RE: RESPONSE TO INFORMATION REQUEST IN RELATION TO THE DEVELOPMENT APPLICATION FOR A DEVELOPMENT PERMIT FOR THE MATERIAL CHANGE OF USE (DUAL OCCUPANCY) AND RECONFIGURATION OF A LOT (1 LOT INTO 2 LOTS) OVER LAND AT 36 WARNER STREET, PORT DOUGLAS, MORE FORMALLY DESCRIBED AS LOT 416 ON RP907333

COUNCIL REF: CA 2025_5837/1 (Doc ID:1324821)

EARTHWORKS AND DRAINAGE PLAN

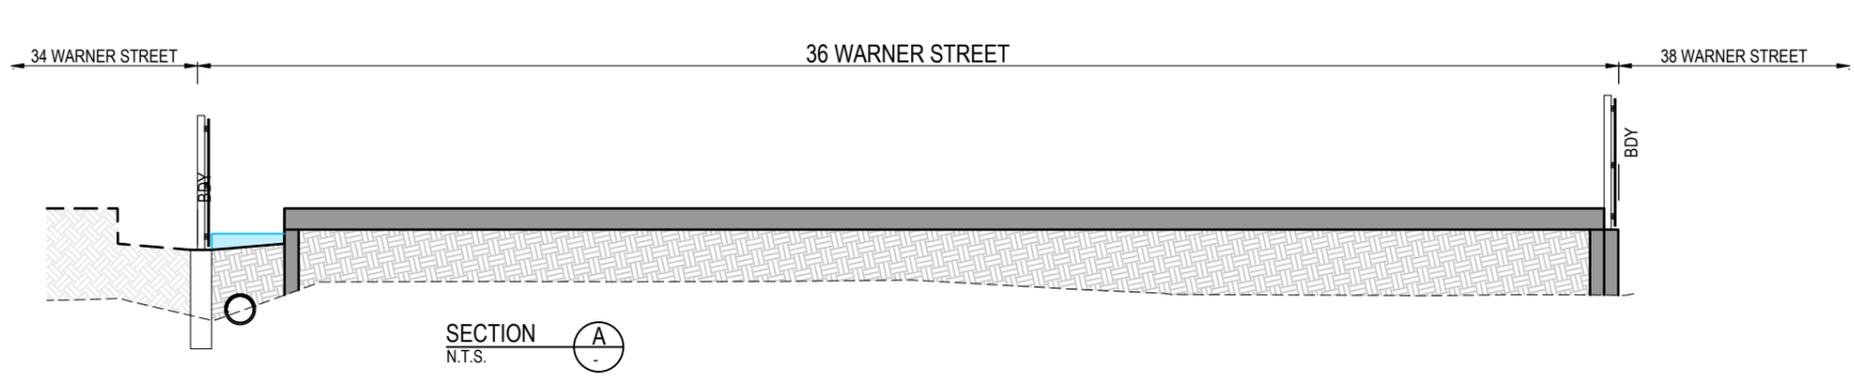
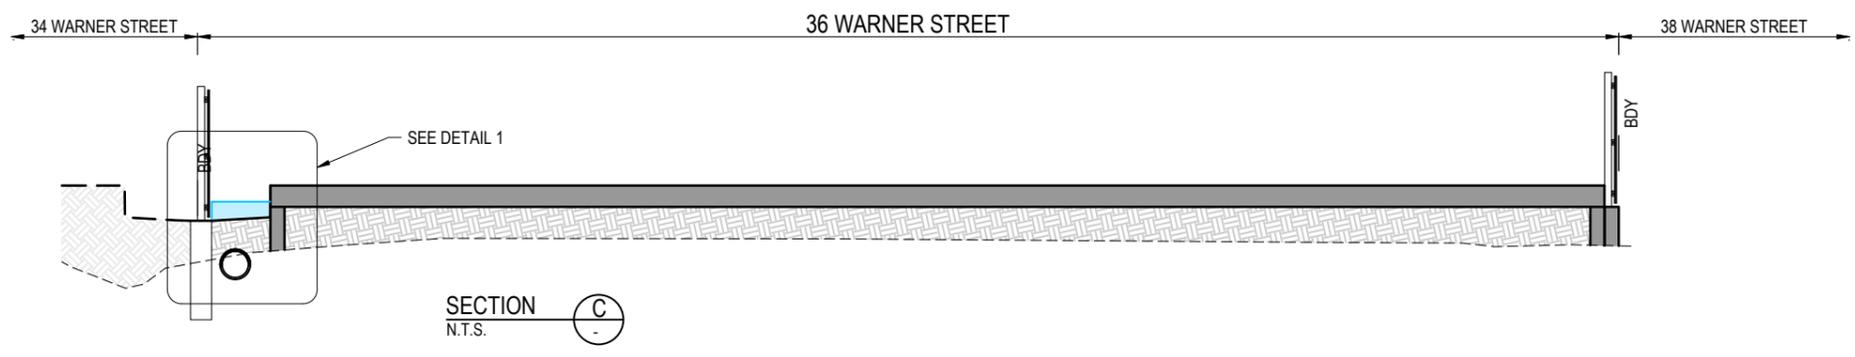
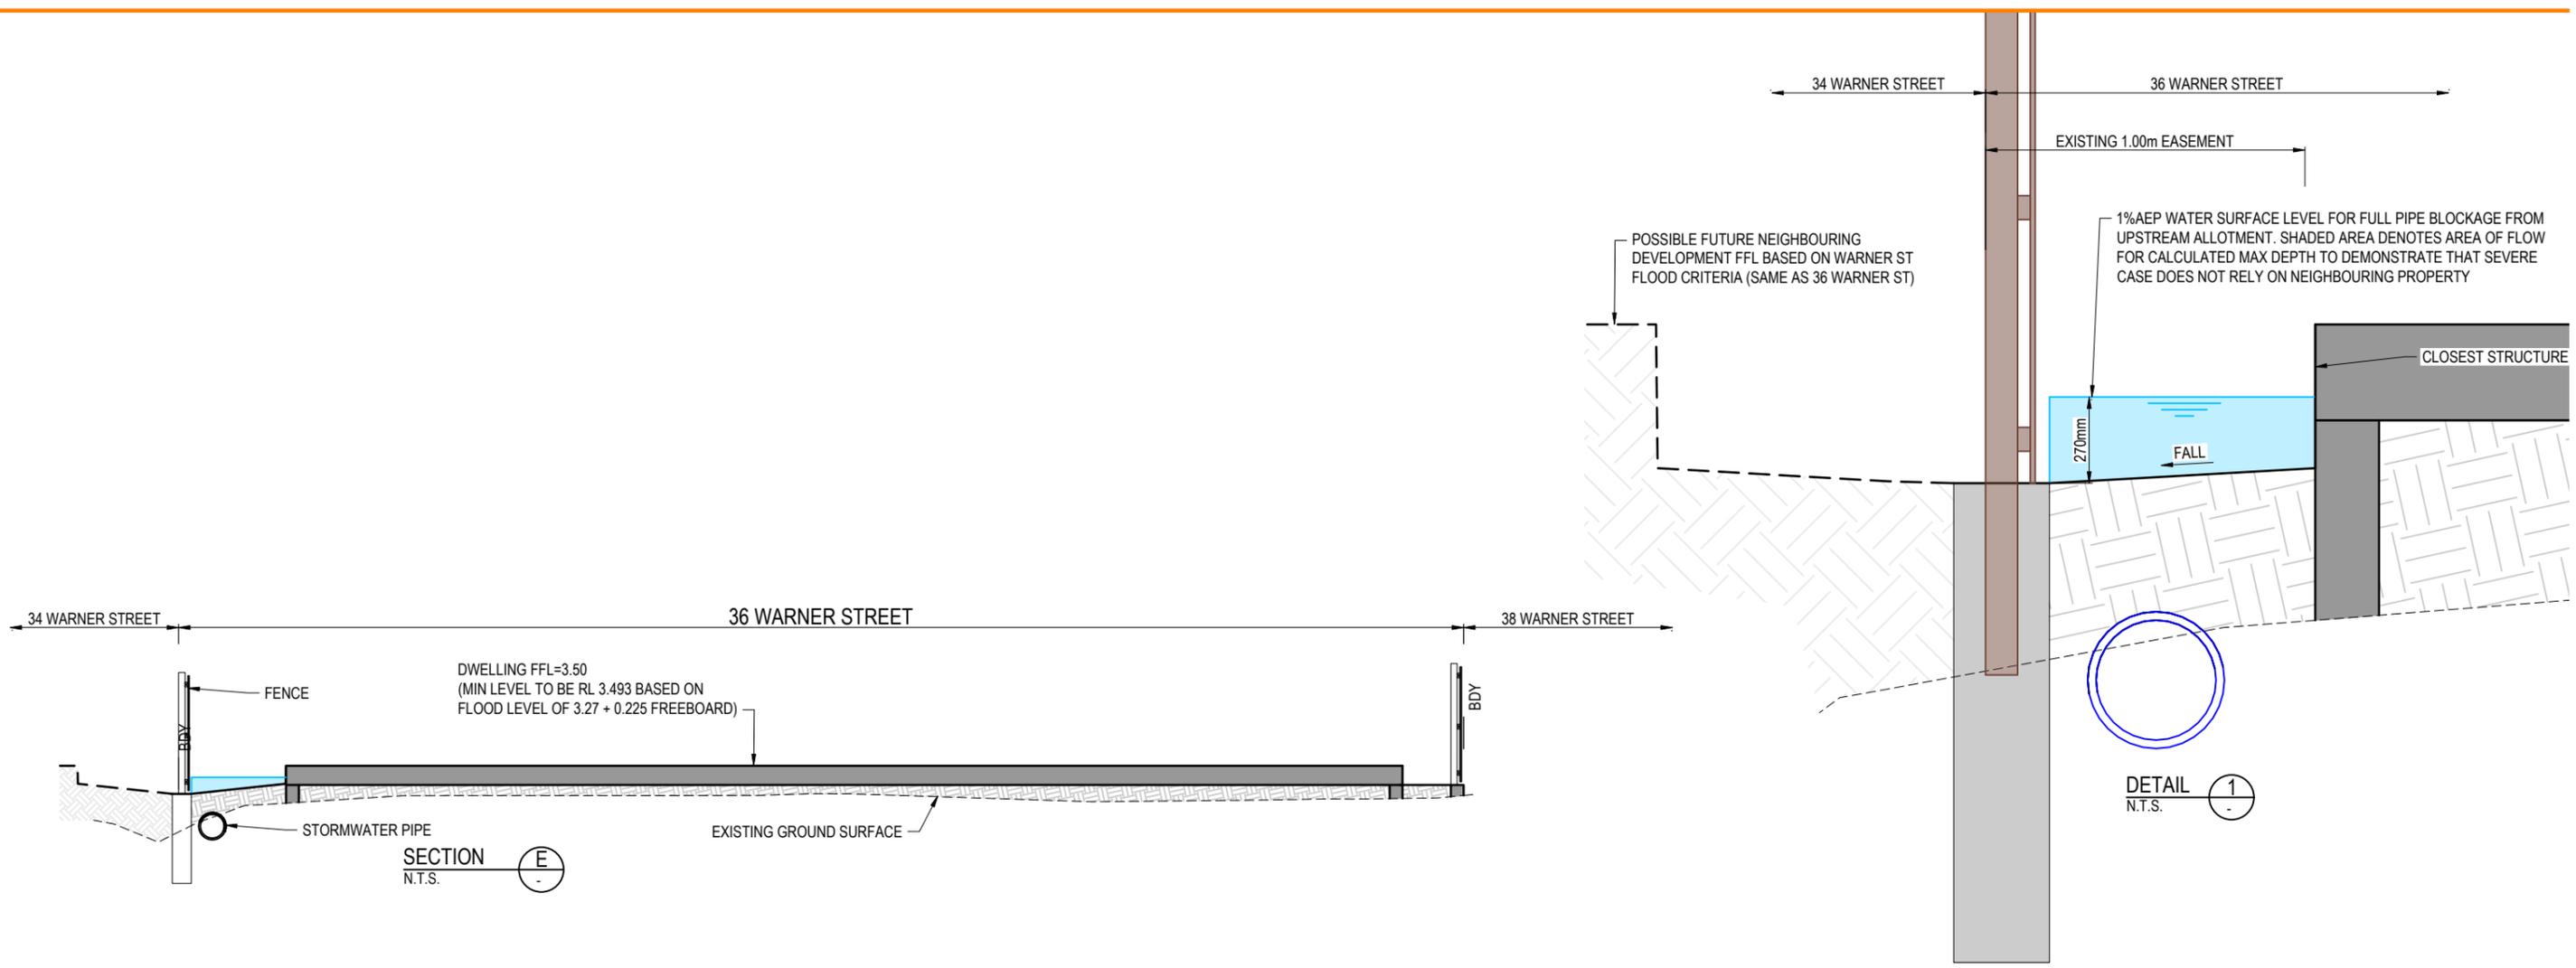
c. Details showing how storm water captured on proposed Lot 1 will be conveyed to the storm water pit located in the south-western corner of existing Lot 416;

d. The location of any additional stormwater pits required to service proposed Lot 2; and

Please provide a Plan of Earthworks that shows the areas of the site nominated for cut and fill and volume of any cut or fill.

2b) Refer to the drawings within the drainage file note.

2c) Refer to the drawings within the drainage file note.

2d) Refer to the drawings within the drainage file note.

An earthworks drawing is provided within the Drainage File Note under Attachment 1. A net solid import of approximately 600m³ is estimated

TITLE:
**PART LOWER FLOOR PLAN -
SLEEPING QUARTERS**

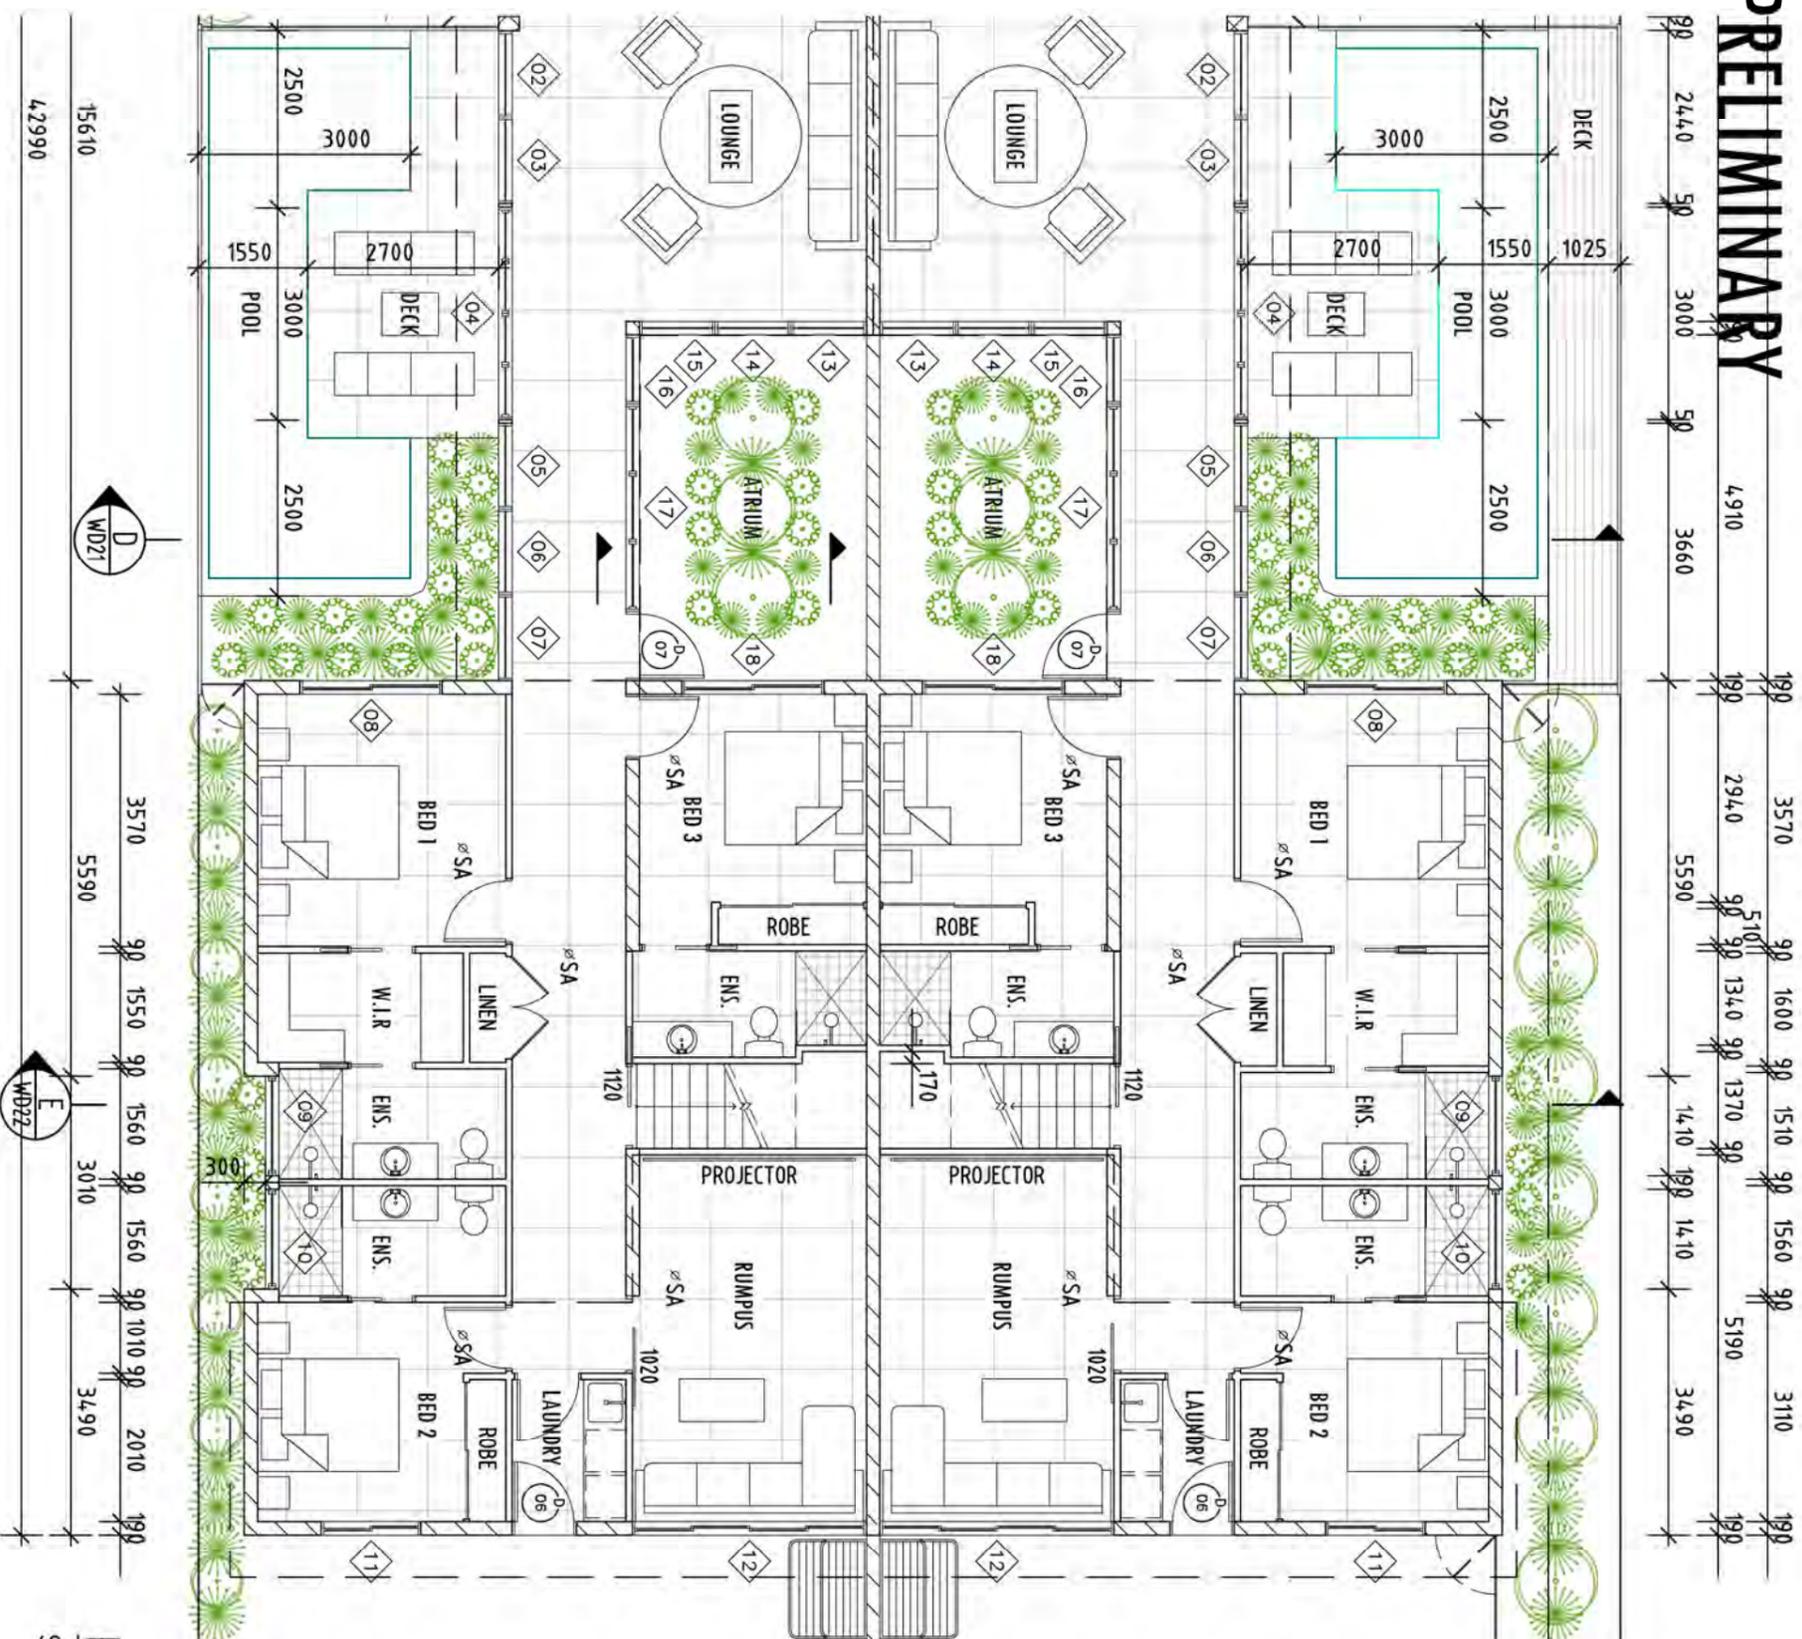
The Part Lower Floor Plan, dated 11 September 2025, Job Number 2444, Sheet No.WD3 submitted with the application shows an area of landscaping between the building and northern end of the eastern side boundary of Lot 416. Please demonstrate how this area of garden will be watered and maintained without relying on access from the neighbouring lot.

Landscaping between the building and northern end of the eastern side boundary of Lot 416 may be maintained via access from the 1m wide drainage easement which burdens the subject site and is free of landscaping.

UPPER FLOOR PLAN
SCALE 1:100

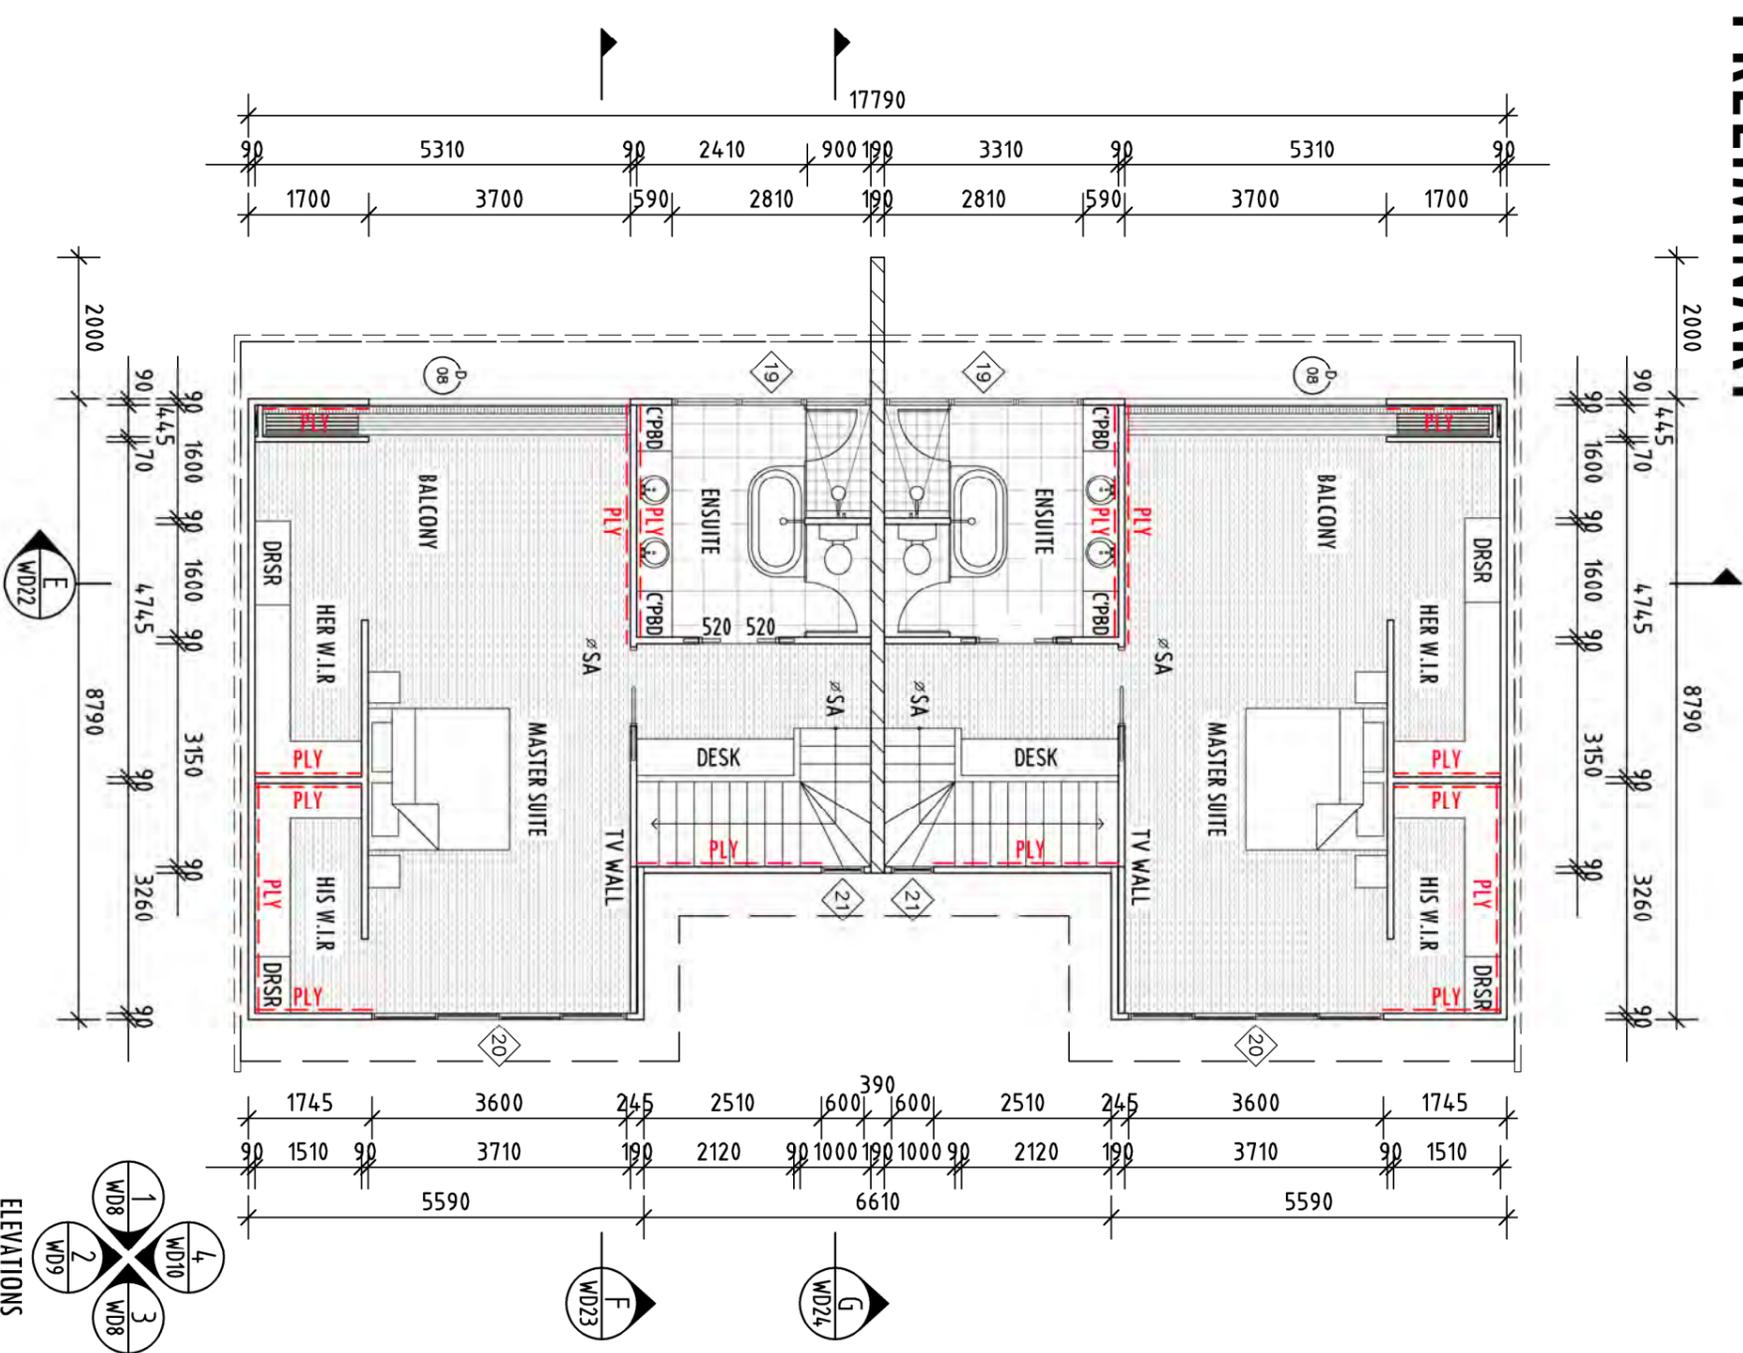
The Upper Floor Plan, dated 11 September 2025, Job Number 2444, Sheet No. WD4 shows a 400mm wide balcony. Please confirm that this is intended width of the balcony.

An Amended Plan Set is provided under Attachment 2. The revised drawings clarify that the balcony area forms an integral component of the Master Suite design rather than a separate, externally projecting structure. The space is enclosed within the primary building footprint but incorporates large stacking doors along the outer elevation. When opened, these doors allow the space to operate in the same manner as a traditional balcony, providing natural ventilation, outlook and an indoor–outdoor transition, while maintaining a cohesive architectural form.
